FINAL PLAT
THE WATERFRONT SECOND ADDITION
AN ADDITION TO WICHITA, SEDGWICK COUNTY, KANSAS

RE: SUB 2002-128 -- Revised One-Step Final Plat of The Waterfront Second Addition

RE: SUB 2002-128 -- Revised One-Step Final Plat of The Waterfront Second Addition

CASE NUMBER: SUB 2002-128 -- THE WATERFRONT SECOND ADDITION

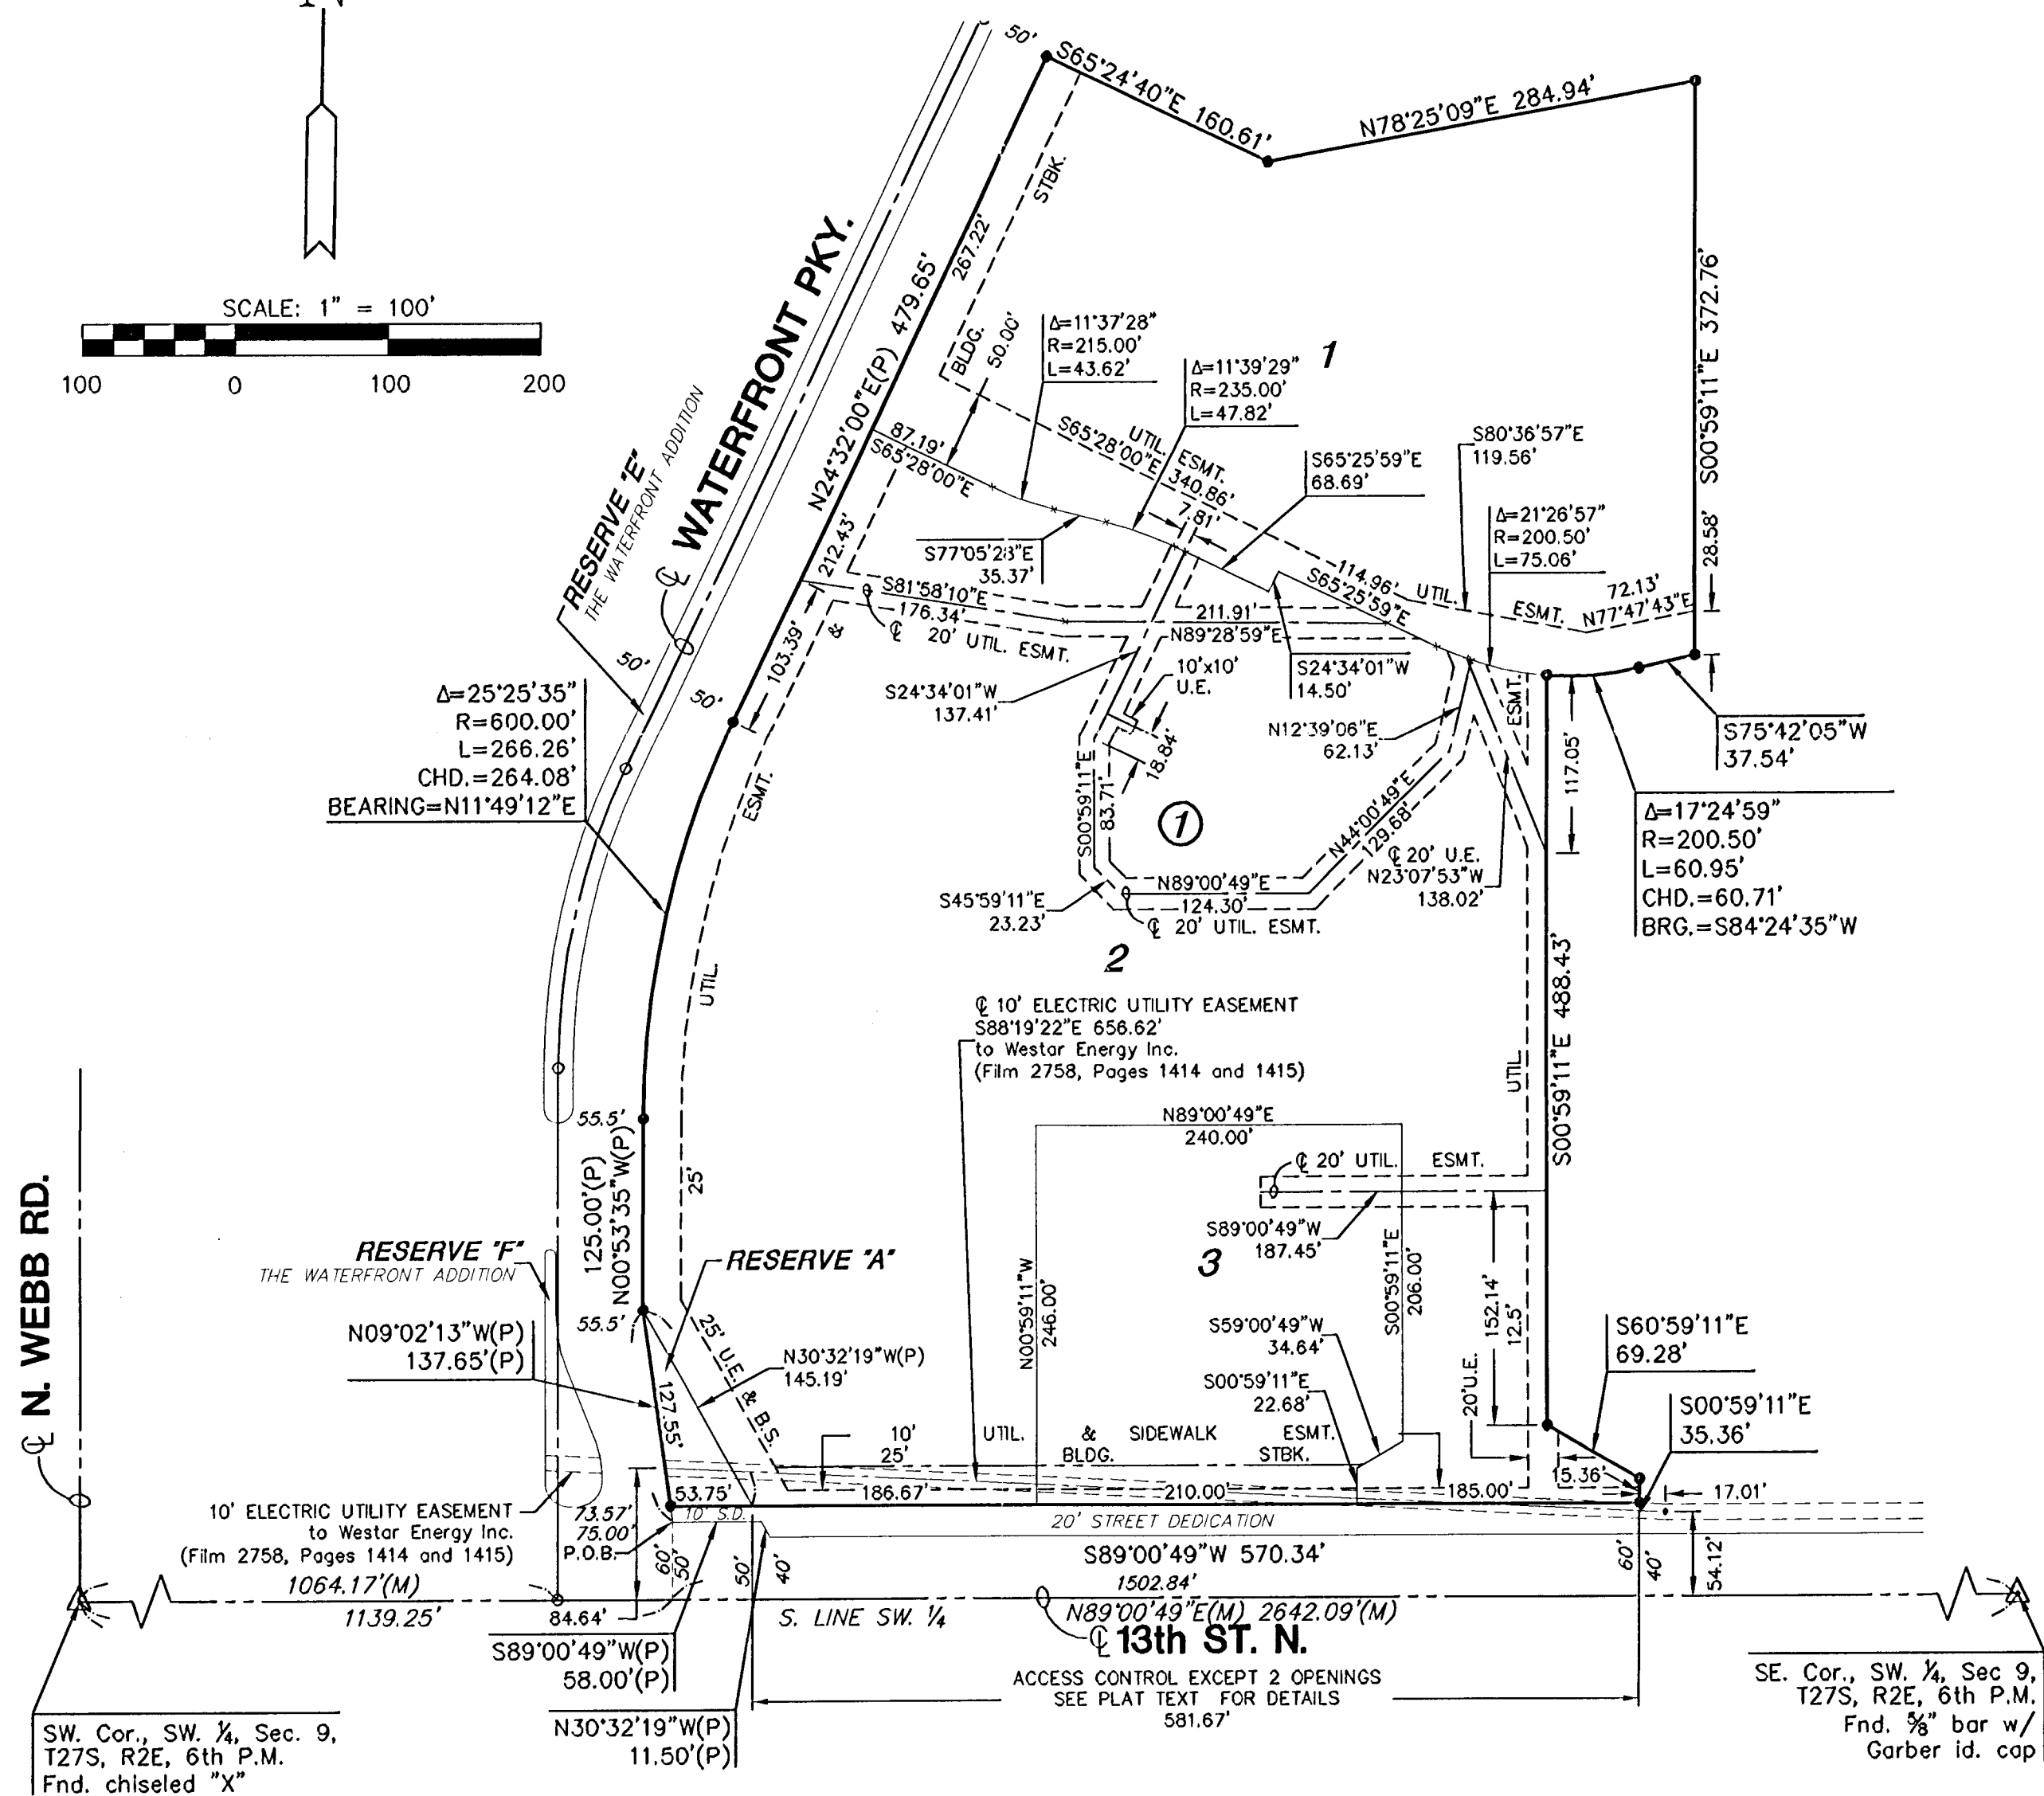
- A. The applicant shall guarantee the extension of sanitary sewer and City water to serve the lots being platted.
- B. If improvements are guaranteed by petition, a notarized certificate listing the petitions shall be submitted to the Planning Department for recording.

- C. **City Engineering** needs to comment on the status of the applicant's drainage plan. *The drainage plan is approved.*
- D. The plat proposes two access openings along 13th Street in accordance with minimum spacing standards of the access management regulations.

- E. "13th St N" shall be correctly denoted on the plat.
- F. **Traffic Engineering** has requested a petition for a left turn lane into the full movement drive.

- G. **County Surveying** advises that the 30-ft utility easement needs located.
- H. The applicant shall submit an avigational easement covering all of the subject plat and a restrictive covenant assuring that adequate construction methods will be used to minimize the effects of noise pollution in the habitable structures constructed on subject property.

- J. The signature line for the City Clerk needs to be revised to reference "Karen Schofield".
- K. The MAPC signature block needs to reference "Ronald L. Marnell, Chair".

- L. The platlor's text shall include language that a drainage plan has been developed for the plat and that all drainage easements, rights-of-way, or reserves shall remain at established grades or as modified with the approval of the applicable City or County Engineer, and unobstructed to allow for the conveyance of stormwater.

- N. The applicant's engineer is advised that the Register of Deeds is requiring the name(s) of the notary public, who acknowledges the signatures on this plat, to be printed beneath the notary's signature.
